METROPOLITAN GOVERNMENT OF NASHVILLE AND DAVIDSON COUNTY

STAFF RECOMMENDATION 1809 Sweetbriar Avenue June 20, 2012

Application: Infill and Accessory structure
District: Belmont-Hillsboro Neighborhood Conservation Zoning Overlay
Council District: 18
Map and Parcel Number: 11704006000
Applicant: Brent Craig, Rigid Development
Project Lead: Melissa Baldock, melissa.baldock@nashville.gov

Description of Project: The applicant is proposing to construct a new one-and-half-story house and a two-story accessory structure on a vacant lot.

RIGID DEVELOPMENTS, LLC
 DETACHED GARAGE
 20x24 SQ FT.: 434
 DATE: 06/05/11

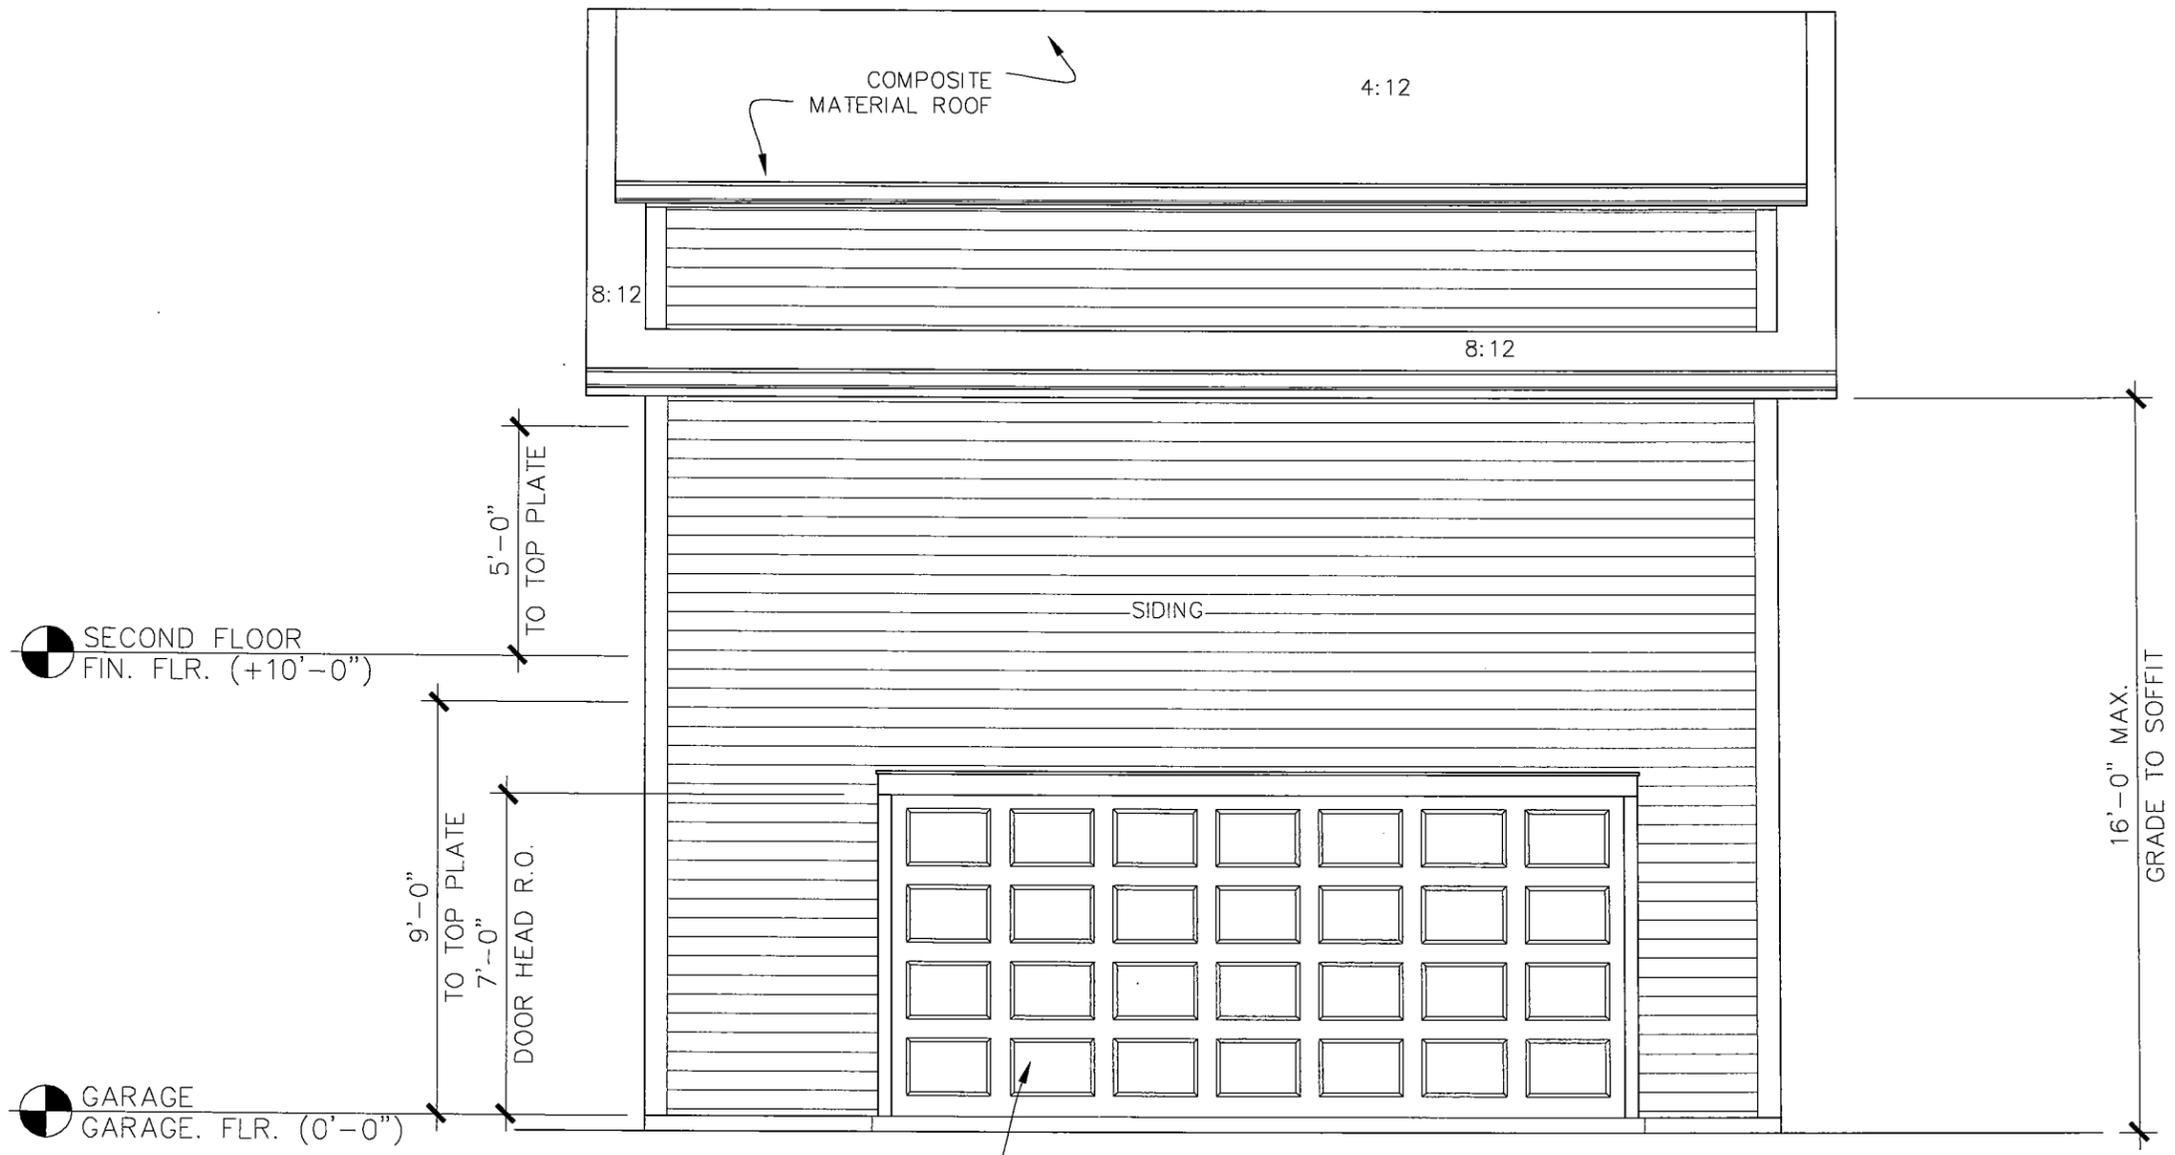
The accessory structure is proposed to have an eave height of sixteen feet (16') and a ridge height of twenty-four feet, six inches (24'6"). Staff finds that the height of the accessory structure is not subordinate to the proposed infill, which will have an eave height of twelve feet, nine inches (12'9") and a ridge height of twenty-six feet, nine inches (26'9"). Moreover, the accessory structure is not subordinate to the immediate historic context, where the primary structures range in height from eighteen feet to twenty-four feet (18'-24'). Staff asks that the ridge height be lowered to approximately twenty feet (20') from grade and that the eave height be lowered by a minimum of two feet (2') so as to be subordinate to the infill and to the neighborhood context. Staff notes that new drawings showing the grade of the site as it relates to accessory structure are necessary to ensure that the eave height and ridge height are truly below the ridge and

eave height of the primary structure. Lastly, staff asks that a trim board be added to the garage at the floor level to help minimize the perceived height of the structure.

9. The ridge height of the accessory structure be a maximum of twenty feet (20') and the eave height be lowered by a minimum of two feet (2').
10. A trim board be added to the accessory structure's floor level, and staff approve all of the structure's windows, doors, and roof color.
